**PARISH OF ASCENSION**  
**OFFICE OF PLANNING AND DEVELOPMENT**  
**PLANNING DEPARTMENT**

**Planning Commission**

January 11, 2017 - 6:00 PM

**AGENDA**

| DRAWING:   | C3.00    | DATE:                    |

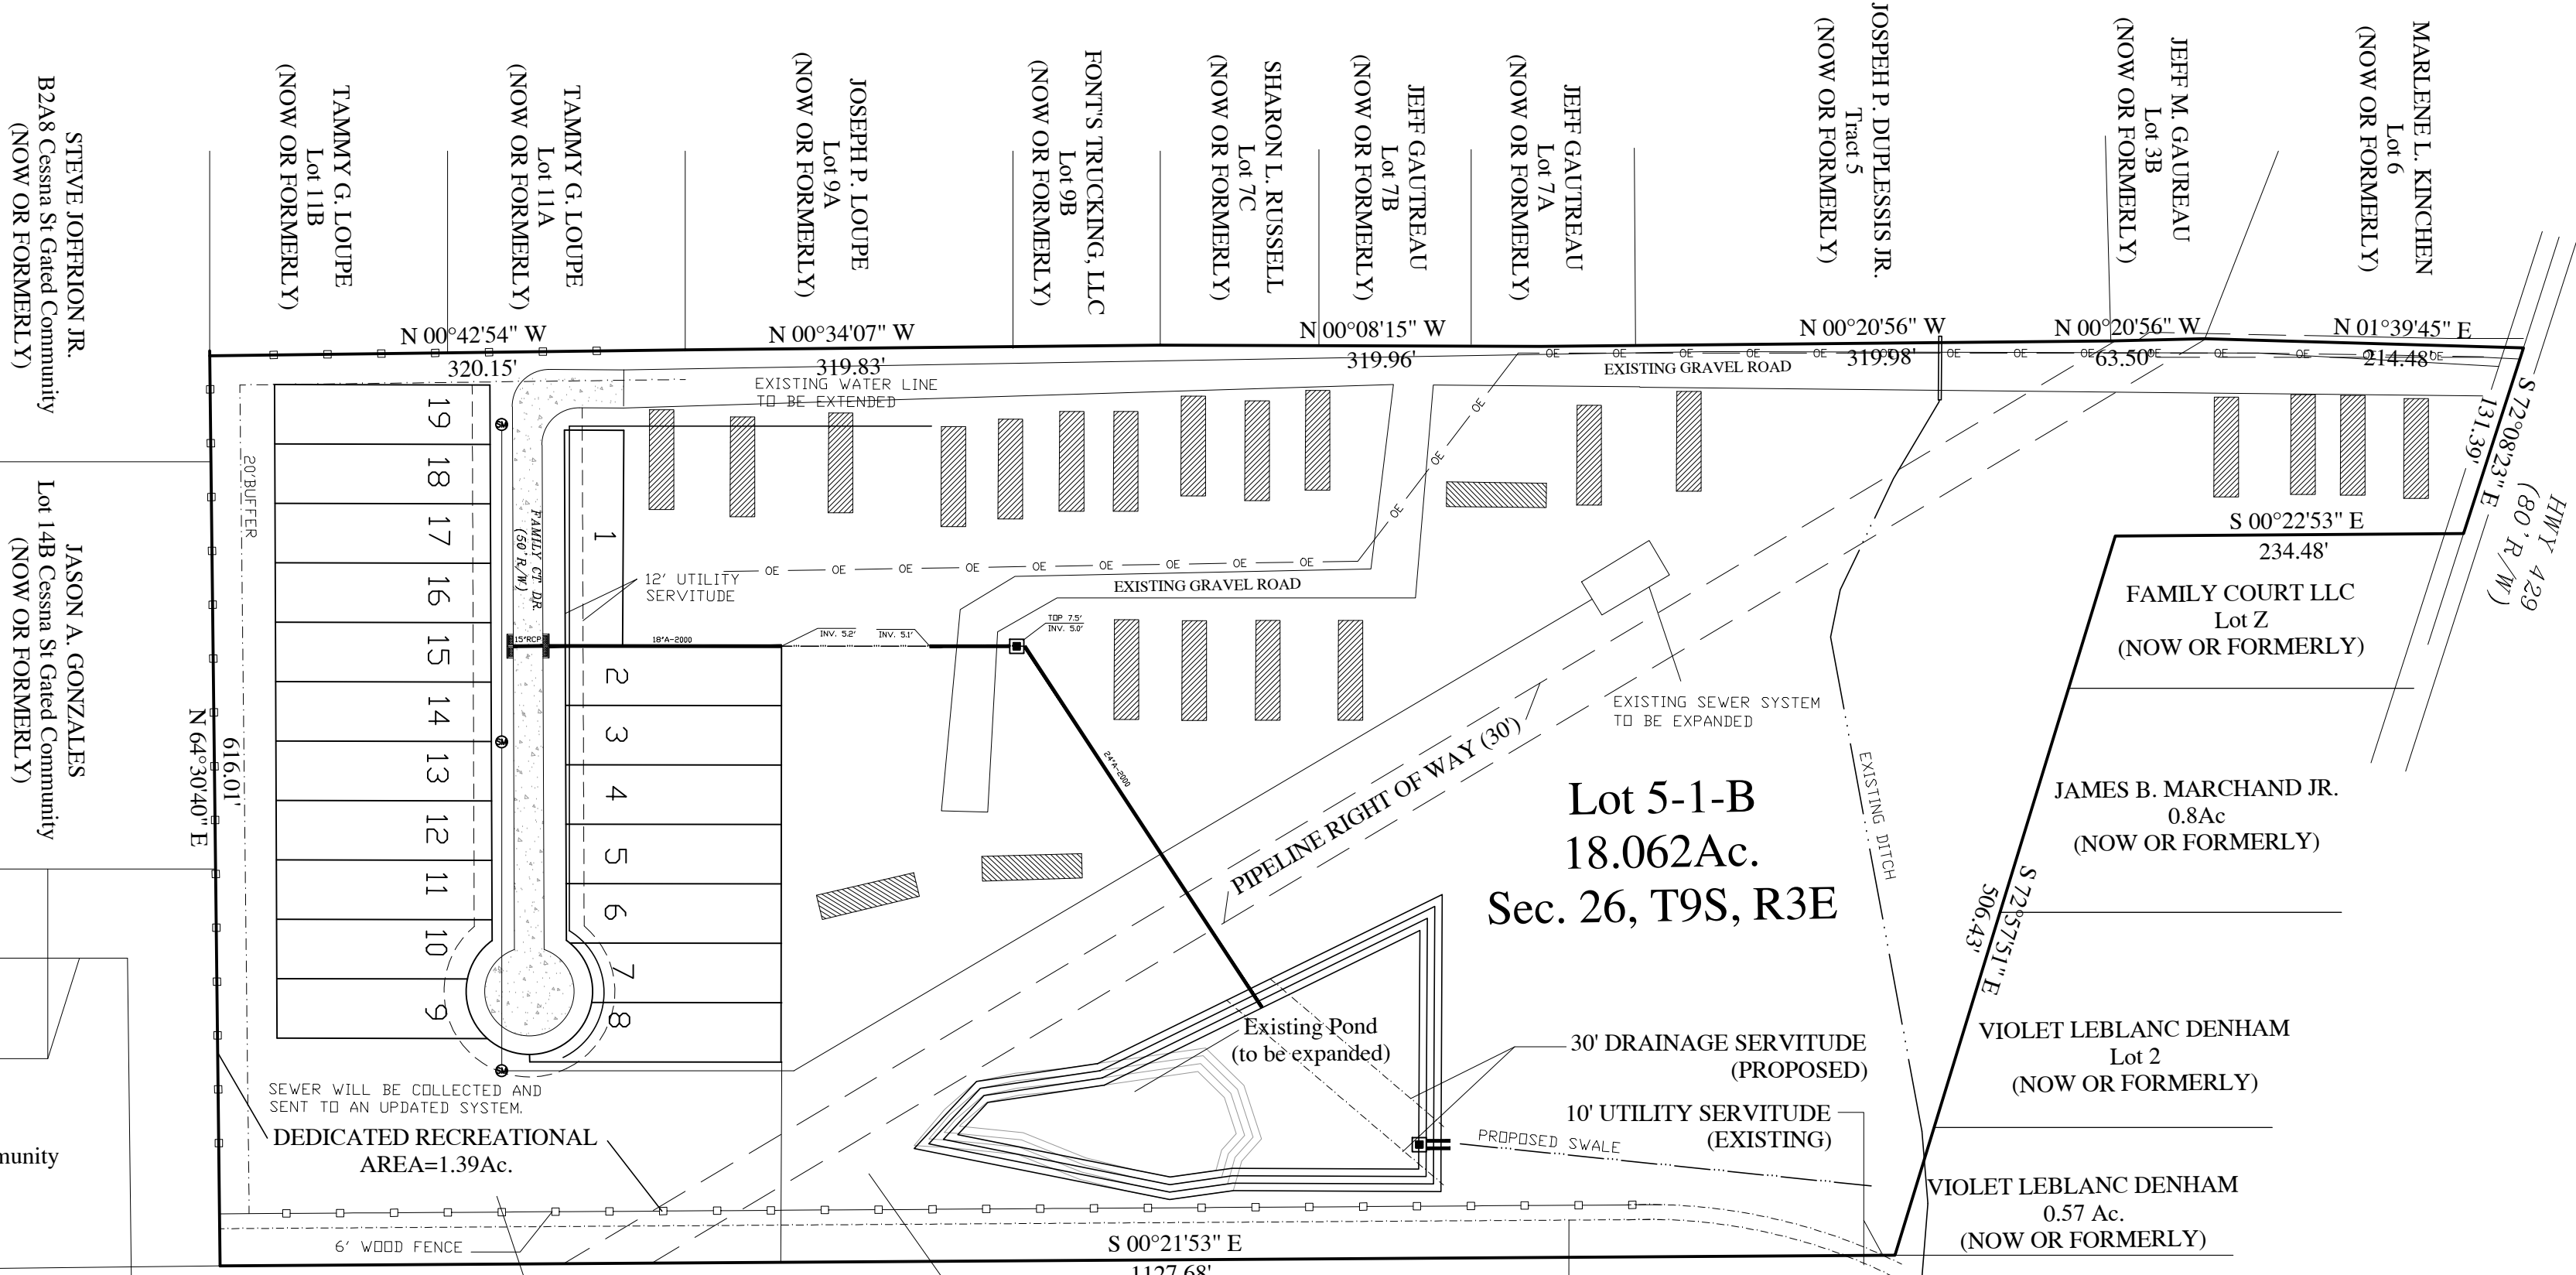
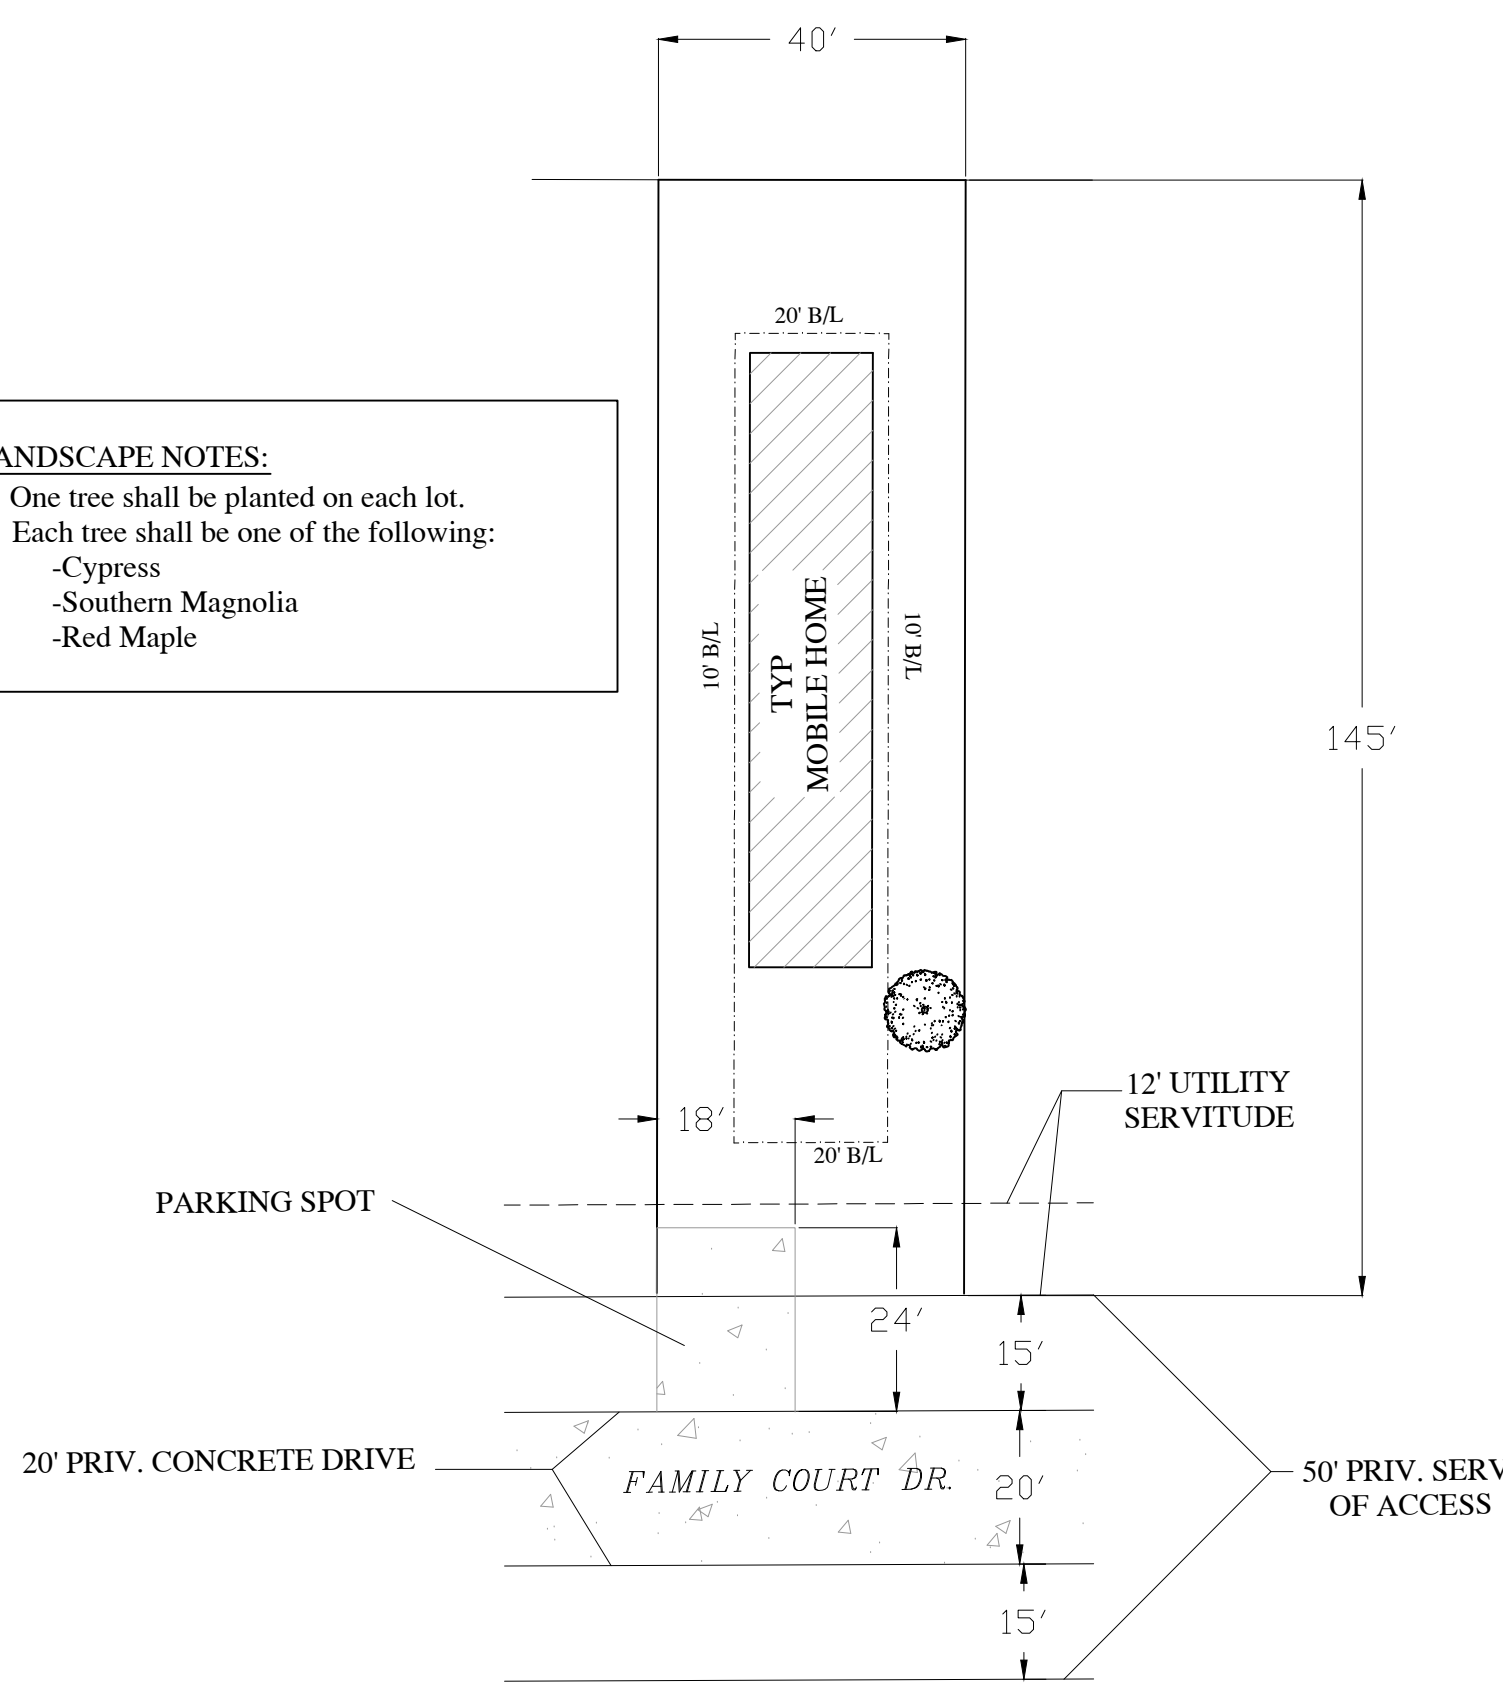
6. The typical section notes two 20' wide lanes instead of 10' lanes as depicted in the typical mobile home space detail and stated in the drainage study report. Revise typical section to match plat and drainage study. Ensure all other dimensions on the typical street section (i.e. ROW width, utility servitude, etc.) are correct as well. **This has been updated on the plat.**

7. Change side drain boxes in the street typical section to concrete instead of brick as currently depicted. **This has been updated on the plat.**

15. Per Section 17-8051A, minimum of 10' wide utility servitudes are required. The typical street section shows 12' utility servitudes, but the typical mobile home space and plat show 15' widths. Review and revise for consistency. **This has been updated on the plat.**

# REVISED PRELIMINARY PLAT OF OAKS ON THE BLUFF ESTATES

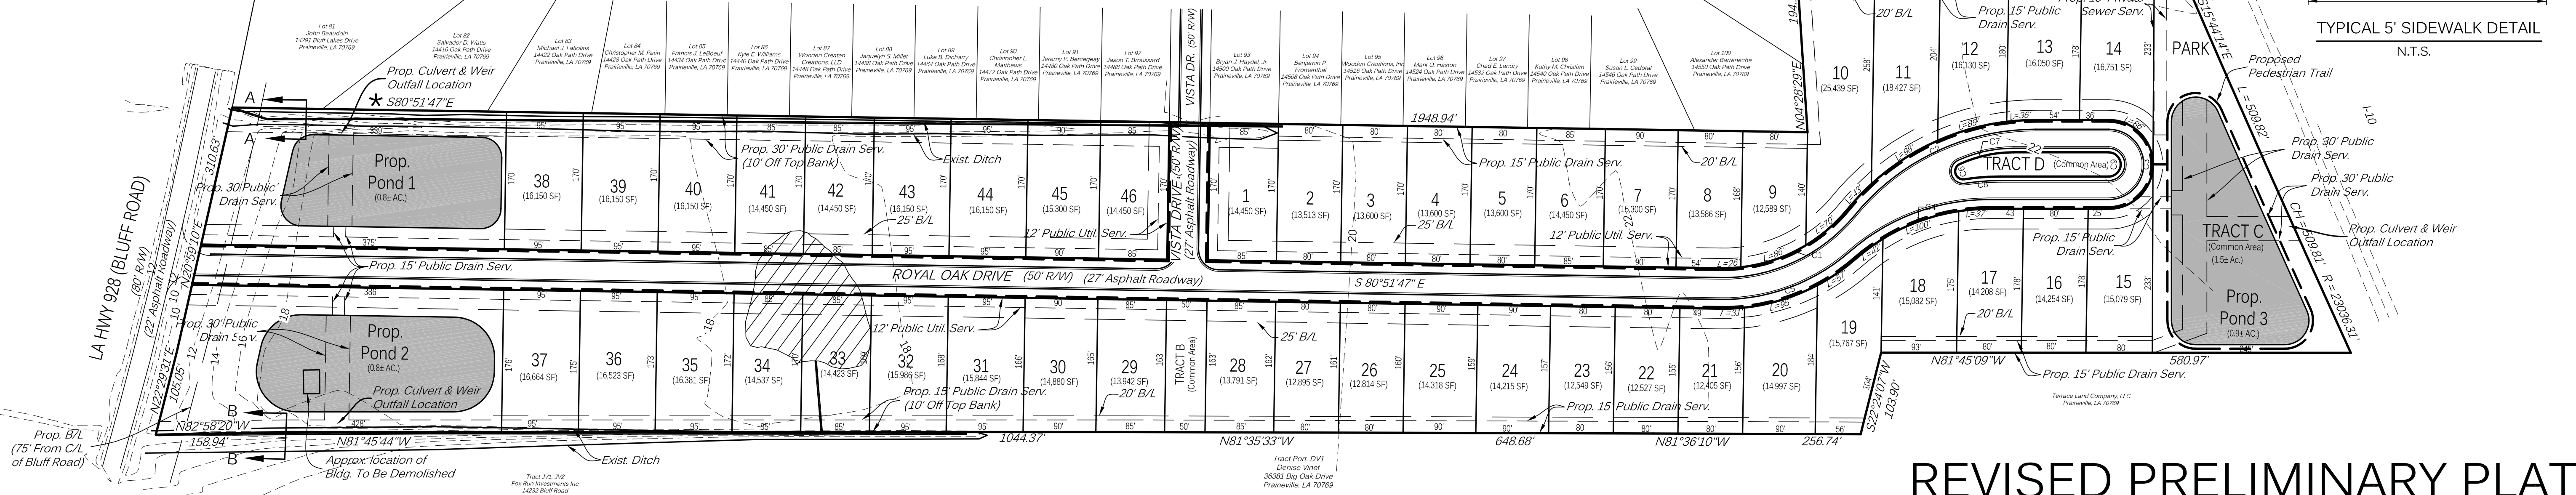
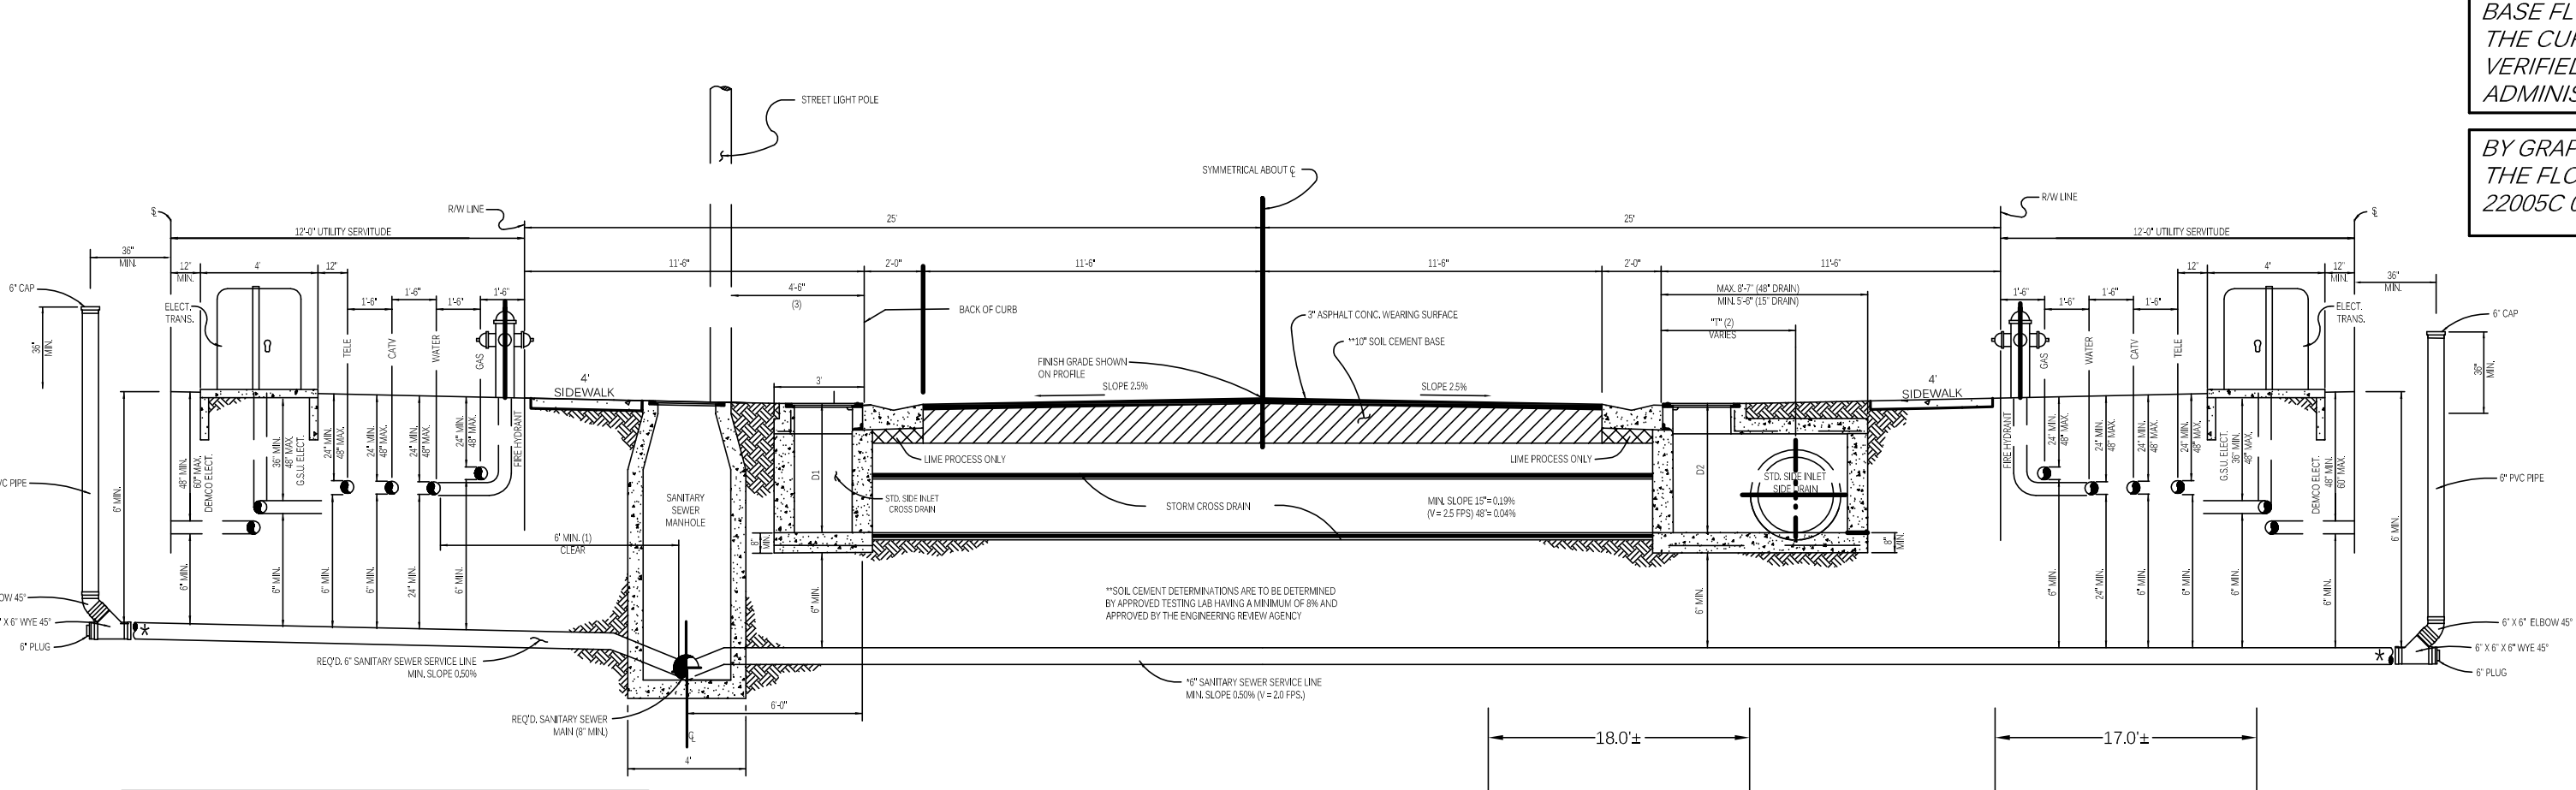
- **The consultant stated the plat was updated to remove the 10" soil cement base, but the 10" base is still depicted in the typical street section and noted as such under the 'Streets' general information. Further confirmation of this street section is required.**
- **Per section 17-4035, alleys shall be provided for all commercial and industrial lots unless the Planning Commission waives this requirement based on the assurance that provisions will be made to provide service accessibility to all lots, such as off-street loading, unloading, and parking consistent with and adequate for the uses proposed.**
- **Traffic turn lane analyses warrant a left turn lane and right turn lane on Hwy 30 at the Business Parkway intersection with La 30 and a westbound right turn lane at the future right-in/right-out access drive from Lot 1.**
